**AGENDA**

**BOARD OF ADJUSTMENT MEETING**

- a) Public Hearing on to receive comments on a variance request to Code of Ordinances Article II. Sec. 103-58 (b)(12). A request of an accessory building which the proposed location affects the setbacks of the property located at 8321 Windway Dr. and more particularly described as BCAD Property #343484.

## 8321 Windway Drive – Request for a Building Permit Variance

PROPOSED CONSTRUCTION  
AREA  
22' x 11'8"

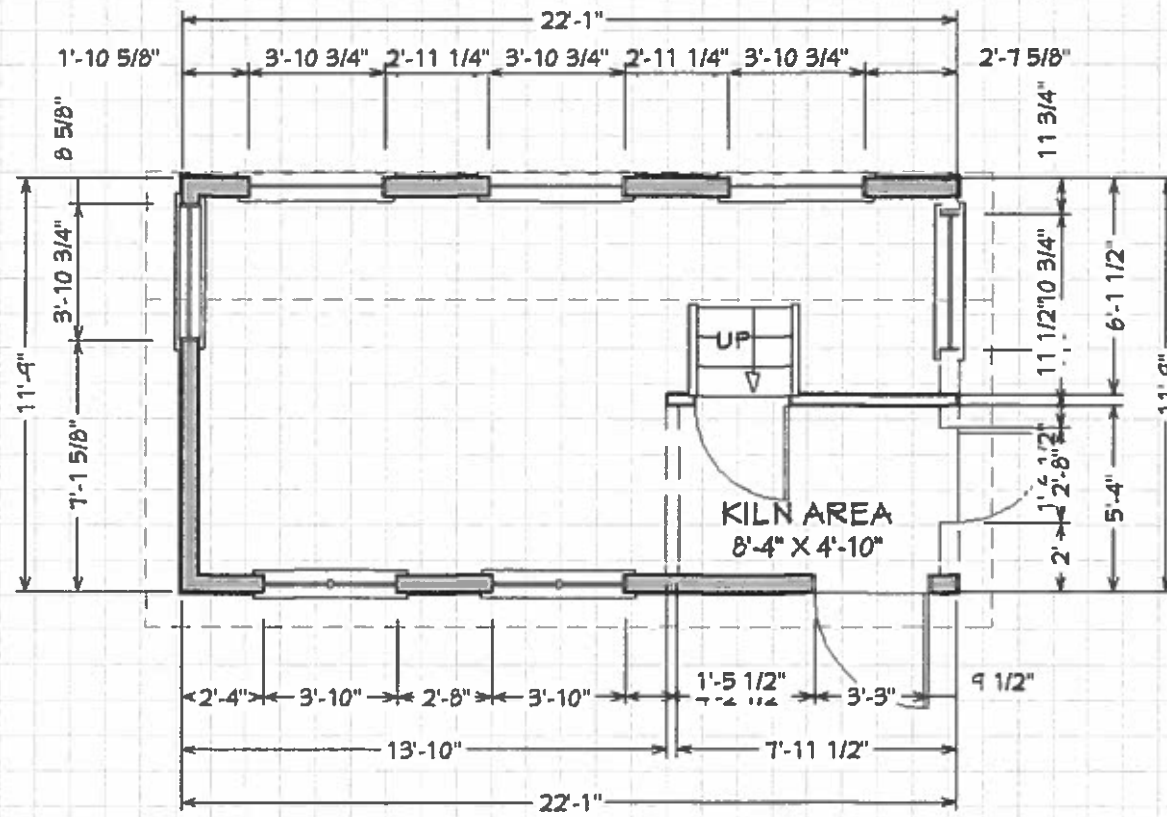
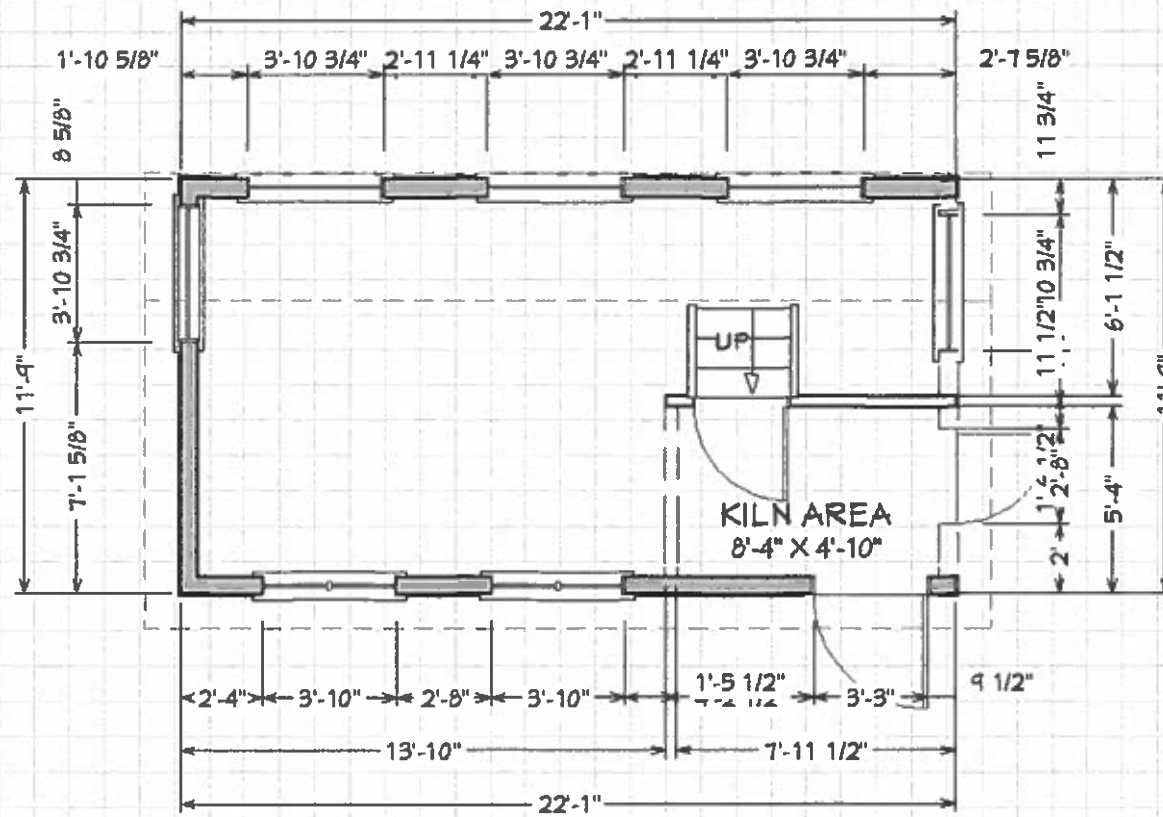
Structure must be atleast 10' from main house and 3' from all property lines.

Size of structure can not exceed 144 square feet and 9' in finished height above grade.

This is a partial review. Full review pending location and size for structure that meets requirements. Other items needed are electric layout, framing, and engineer approval for existing foundation.

Applicant is requesting a permit to build an accessory building (workshop with a kiln) in an R-2 zoning.

d. All accessory buildings shall be set-back not less than ten feet from the main dwelling and not less than three feet from all lot lines and shall not occupy any portion of easements if placed on permanent foundation. If portable the three-foot setback applies. Masonry buildings shall not be less than ten feet from all lot lines and shall not occupy any portion of easements.

e. Excluding masonry buildings, buildings will not exceed 144 square feet of interior space nor nine feet in height (above grade level). The term "grade level" is defined as the highest point of elevation of the finished surface of the ground, paving, or sidewalk between the main structure and the property line.

1. No plans for ventilation over the kiln area were submitted.
2. Needs a carbon monoxide alarm in the kiln area.
3. The Kiln needs to be at least 18 inches from non-combustible surfaces and 36 inches from combustible surfaces.
4. Need a mounted and charged 10 lbs. dry chemical ABC fire extinguisher.
5. The kiln must be mounted on a concrete floor at least 2 inches thick and extend 12 inches beyond the kiln.

VIEW FROM ALLEY

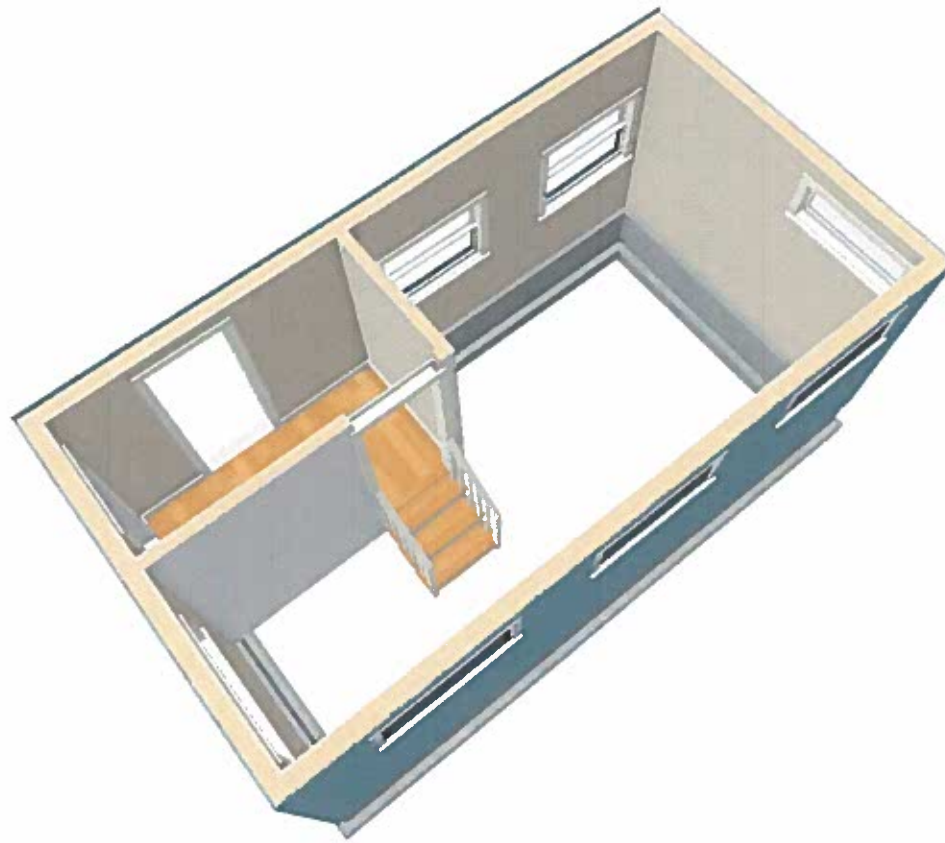
This is what we imagine the accessory building to look like, as seen from the alley where the brown fence is presently located. The long windows on three sides would actually be opaque glass blocks to let in some ambient light.
